Office Action Summary

10/729,235

DETAILED ACTION

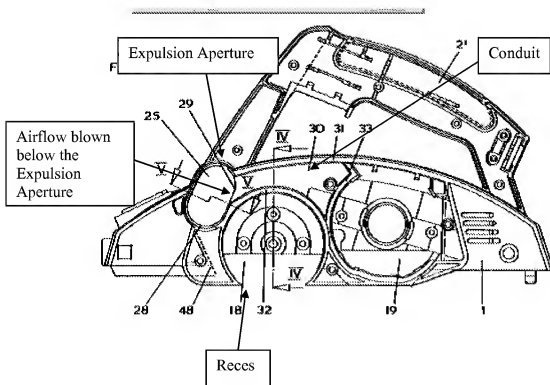
Claims 15, 3 and 16-21 are rejected under 35 U.S.C. 102(b) as being anticipated by Eichberger et al. (5,815,934). With regard to claims 15-20, Eichberger discloses a planer

comprising a shoe, the shoe defining an aperture (fig. 1); a body mounted on the shoe (fig. 1), the body defining an exhaust passage (25) having a first exhaust aperture on a first side of the body, and a second exhaust aperture on a second side of the body (26, 27; col. 3, lines 55-58) and including a wall, the wall defining a recess (18); a cutting drum (15) rotatably mounted within the recess, the cutting drum projects through the aperture in the shoe; an expulsion aperture (28, 29; col. 3, lines 59-67) connecting said recess to said exhaust passage (col. 3, lines 64-67; a motor (8); a cutting blade mounted a periphery of the cutting drum (col. 3, lines 18-20) an airflow generator (11); a conduit defined within the body (30); wherein said exhaust passage (25) is configured so that the airflow directed into the exhaust passage flows in a substantially upward direction to entrain and remove debris and a removably deflector (54), the deflector insertable through one of the first and second exhaust apertures and connectable to the exhaust passage for guiding the airflow and entrained debris from within the body to outside of the body.

As to the recitation, *"wherein said exhaust passage is configured so that the airflow directed into the exhaust passage flows..."* Examiner notes the term into is understood as the airflow going *into* the passage. Eichberger teaches this airflow is directed in a substantially upward direction because the airflow is coming from a lower location, i.e. the cutting drum is positioned below the exhaust passage therefore the airflow and debris from the cutting drum is directed in a substantially upward direction so as to facilitate removal of the debris via the exhaust passages
